CITY OF CONWAY, ARKANSAS HISTORIC DISTRICT COMMISSION

May 22, 2023 • 5:30pm • 1111 Main Street

HISTORIC DISTRICT COMMISSION

354 Watkins Street - Exterior modifications

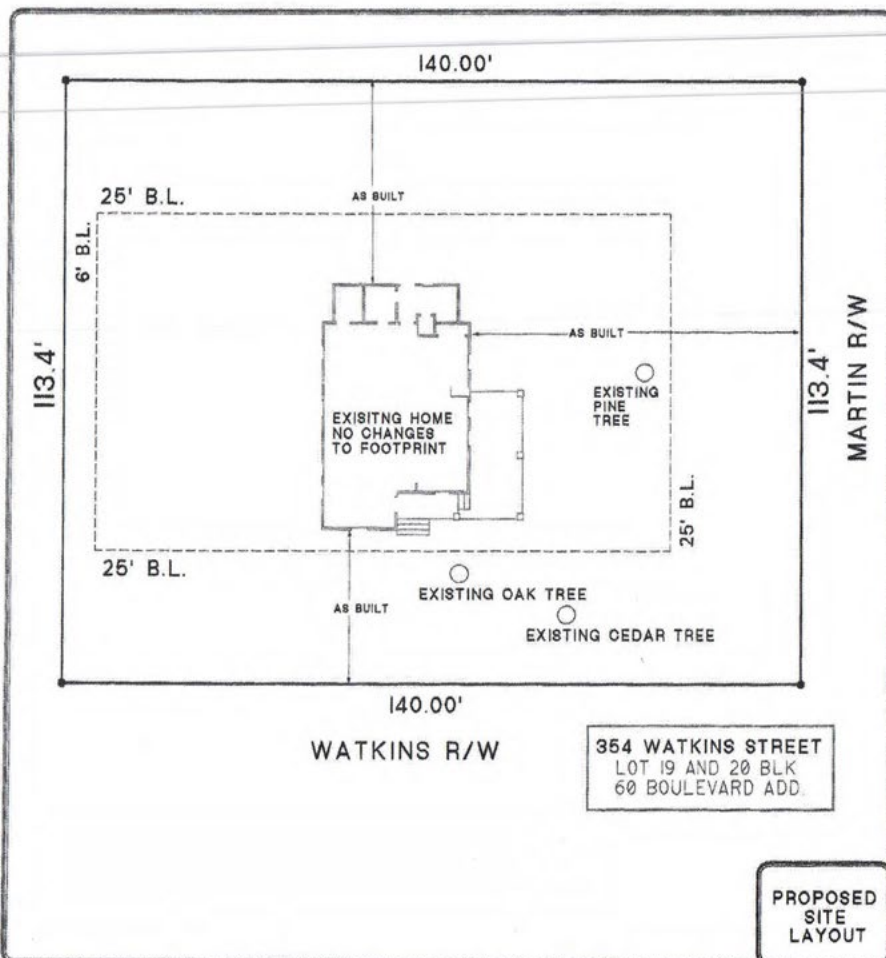
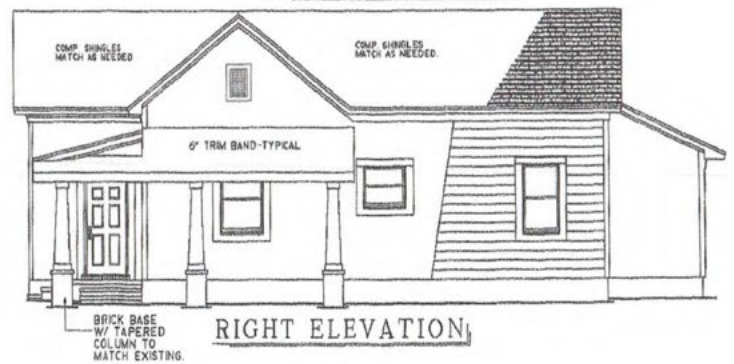
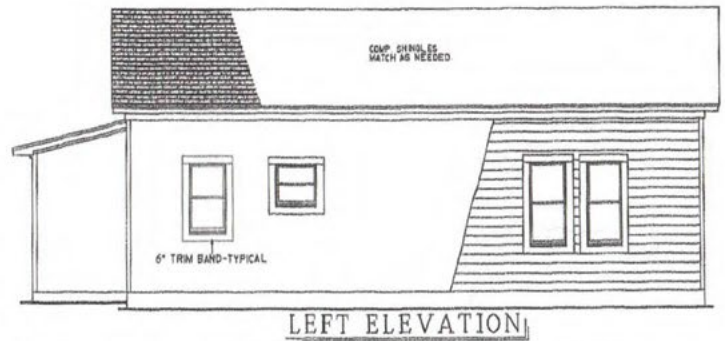
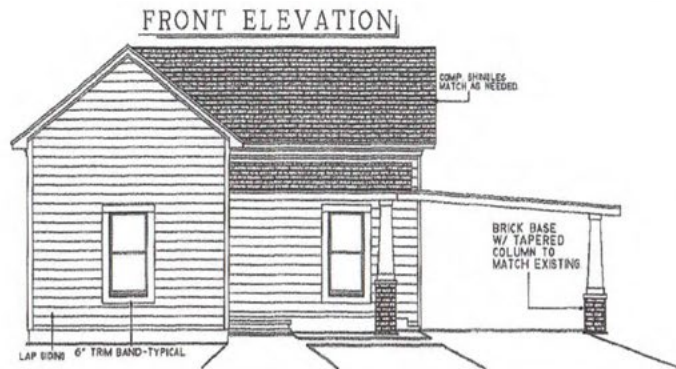
The applicant has removed two windows on the right elevation that will not be replaced. The resulting void is three (3) total windows on the right elevation and the front door.

The applicant has replaced a security door with a white door which matches the windows and trim. Windows are one-over-one. Carport remodel is similar in form and size to original, and proposed columns will improve compatibility with existing porch elements.

Previous siding was vinyl and applicant is proposing to replace portions of the siding with vinyl to match.

Recommend asphalt shingles for any roof repairs/re-roofing. No changes to be made to the pitch or design of the roof.

No shutters have been proposed and it is recommended that shutters not be allowed.

1. Applicant must obtain all applicable building permits* if/when a Certificate of Appropriateness is granted.
**Applicant shall provide proof of appropriate licensure of professionals performing work to the Building Permits Department.*
2. All windows will be required to be one-over-one.
3. Window removal shall be limited to the two already removed. Should another window need to be removed it shall be replaced in a manner that maintains the same number of windows per room as is currently displayed on the plans included with this submittal.
4. Roofing shall be composed of asphalt shingles.
5. No shutters shall be allowed.
6. Applicant must complete/repair house skirt using brick to match existing.
7. Applicant shall provide safe egress from rear portion of house by installing stairs/ramp.

FRONT ELEVATION

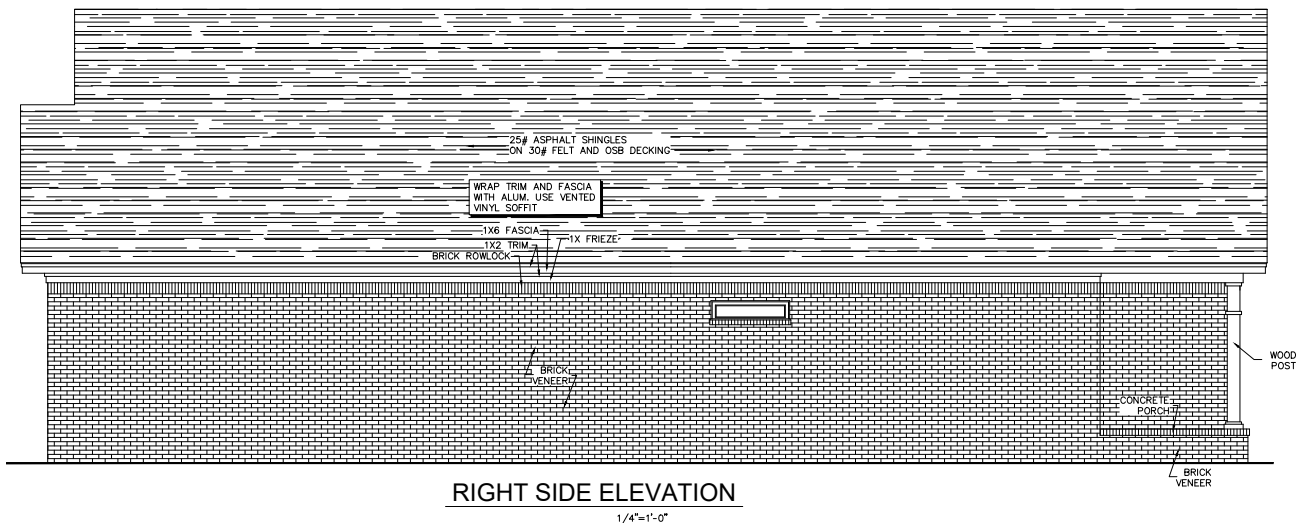
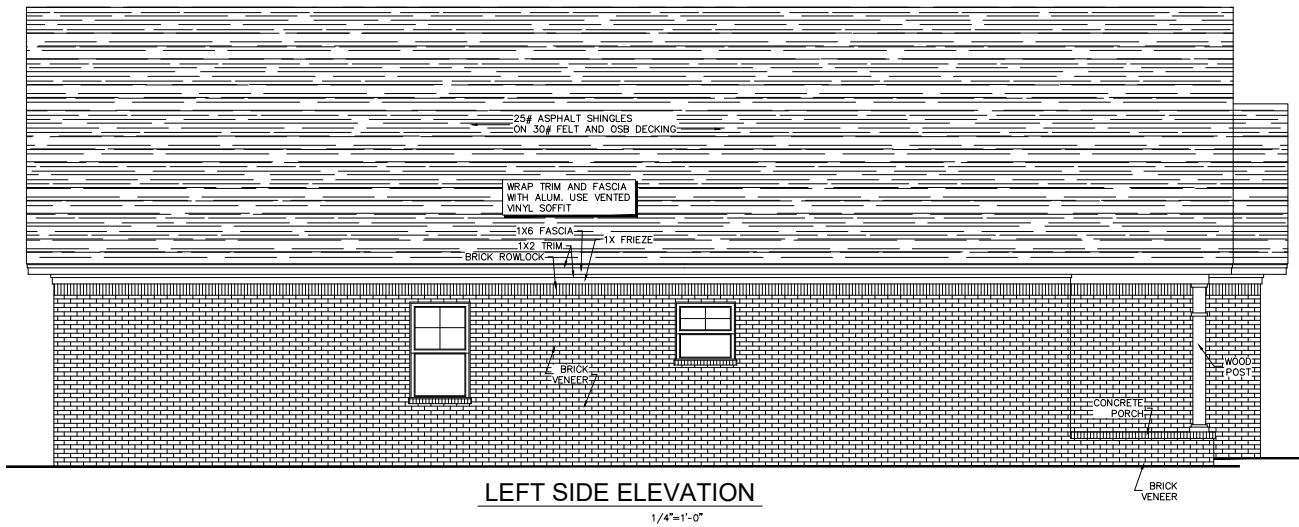
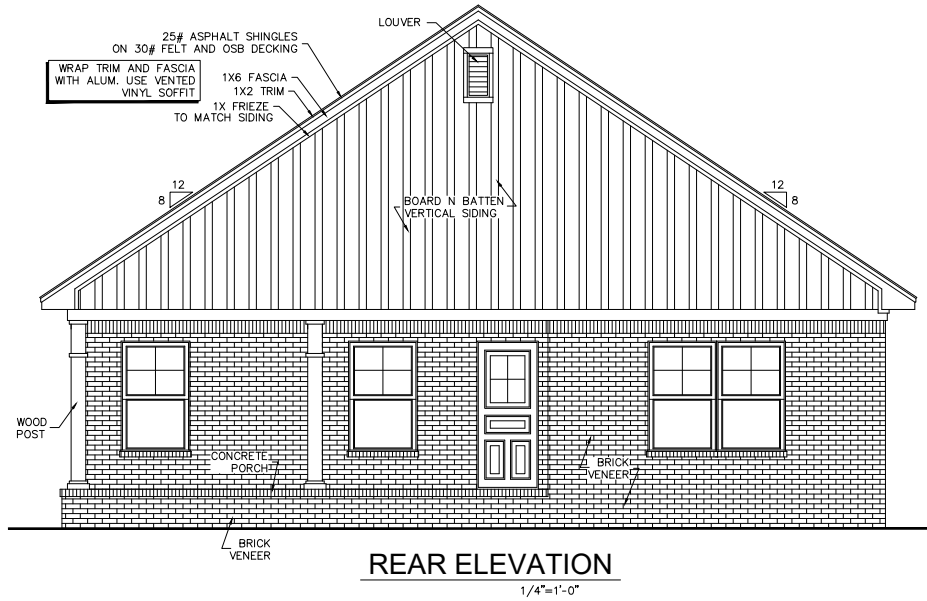
All elevations contain windows including several on the front façade. A calculation of the front elevation will be required to ensure 25-40% of this façade contains windows.

An open front porch with an 7'4" depth is proposed and meets the requirements. The proposed windows should feature wide trim and one-over-one design. If muntin bars are proposed, they must be true divided lights. Fake muntin bars are prohibited.

The applicant is proposing brick and board and batten vertical siding as the materials for construction. Materials used for board and batten siding will need to comply with the approved list of materials.

No shutters are being proposed which is desirable. The applicant is proposing a gable roof. This is compatible with surrounding homes.

1. Windows shall be one-over-one. If muntin bars are used, they must be true divided lights.
2. Board and batten siding should consist of wood or wood substitute such as Hardie® siding/LP® SmartSide® type siding.
3. 25-40% of front elevation must contain windows.
4. No additional parking area, beyond driveway, may be added to the front yard.
5. A 5' sidewalk with 6.5' greenspace is required. Sidewalk must link to any existing sidewalk.
6. Care should be taken to preserve all significant trees on the property. Any canopy tree removed must be replaced by a canopy tree from the approved tree list. Imagery shows at least two significant canopy trees were removed and these will need to be replaced by trees from the approved list.
7. Provide revised plans address windows, sidewalk, and trees to Planning Director for approval prior to issuance of a Certificate of Appropriateness.

③ FRONT
1/4" = 1'-0"

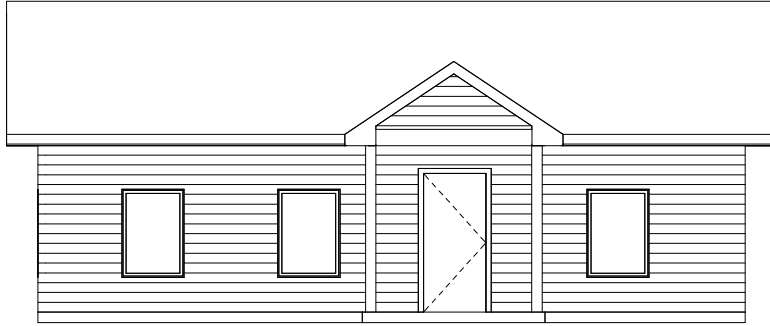
Originally, the front façade of the residence contained four (4) windows. The applicant has removed all four and replaced three (3) with an orientation which differs slightly from the original. This replacement has increased the spacing of the windows and improved the rhythm of the front façade. Similarly, five (5) windows on the left elevation were removed and replaced with three (3) windows with different spacing. On the right elevation, two (2) windows were removed and replaced with different spacing. In instances where replacement was not 1:1, the replacement windows appear wider than the originals, thereby maintaining a consistent void.

The front porch remodel improves the complexity of form. The original porch visually receded into the façade of the structure. The new porch projects from the house with a gable and proposed horizontal siding to match the front siding. The original front door was a metal security door and has been replaced with a white door which matches the new window trim. Window replacement has been one-over-one.

Any replacement of siding or additional materials should be brick, stone, wood, and/or Hardie® siding/LP® SmartSide® type. Applicant proposes a combination of brick (side and rear) and board and batten (front).

Recommend asphalt shingles for any roof repairs/re-roofing. Changes made to the pitch of the porch is consistent with neighboring properties. No shutters have been proposed and it is recommended that shutters not be allowed.

1. Applicant must obtain all applicable building permits* if/when a Certificate of Appropriateness is granted.
**Applicant shall provide proof of appropriate licensure of professionals performing work to the Building Permits Department.*
2. All windows will be required to be one-over-one.
3. Window removal shall be limited to those already removed. Should any other windows need to be removed, they shall be replaced in a manner that maintains the same number of windows per room as is currently displayed on the floor plans included with this submittal
4. All fascia and soffits shall be repaired with wood or a wood-like material such as Hardie® siding/LP® SmartSide®.
5. Roofing shall be composed of asphalt shingles.
6. No shutters shall be allowed.
7. Porch shall have a minimum depth of 6 feet.

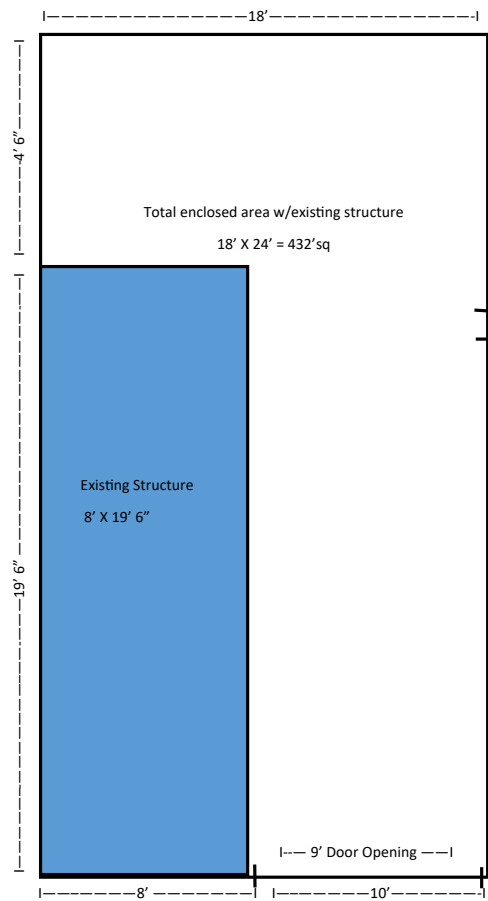
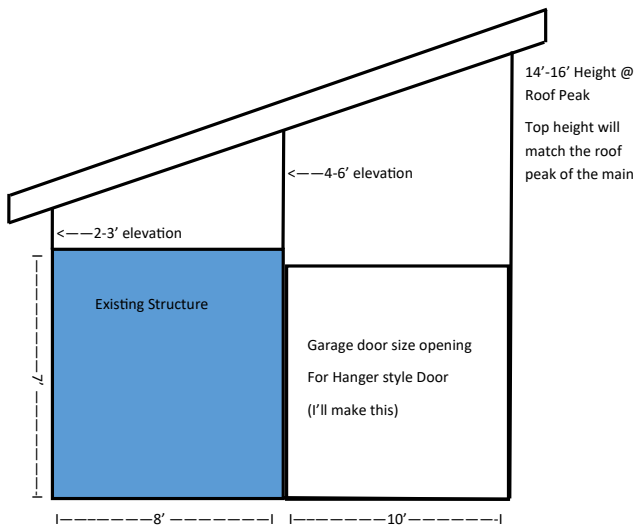
Applicant to use appropriate material for enclosure of carport. Materials must be provided prior to issuing of permit.

Recommend asphalt shingles for roof repairs/re-roofing. Roof height will match the roof peak of the main home.

Applicant is proposing to enclose the carport on the existing foundation. Massing and scale appear to be appropriate.

- Remove old roofing and all support materials
- Replace with shed angle/single angle roof
- Elevate side facing the main house to create matching roof peaks / angles
- Horizontal wood shingles to match existing siding (facing the school)
- Exposed wooden beams stained to match the wooden fence around the property

1. Applicant must obtain all applicable building permits* if/when a Certificate of Appropriateness is granted.
**Applicant shall provide proof of appropriate licensure of professionals performing work to the Building Permits Department.*
2. Roofing shall be composed of asphalt shingles.
3. Exterior materials must consist of stone, wood, or Hardie® siding/LP® SmartSide® type siding.
4. Carport must complement design elements and materials of the home and surrounding structures.
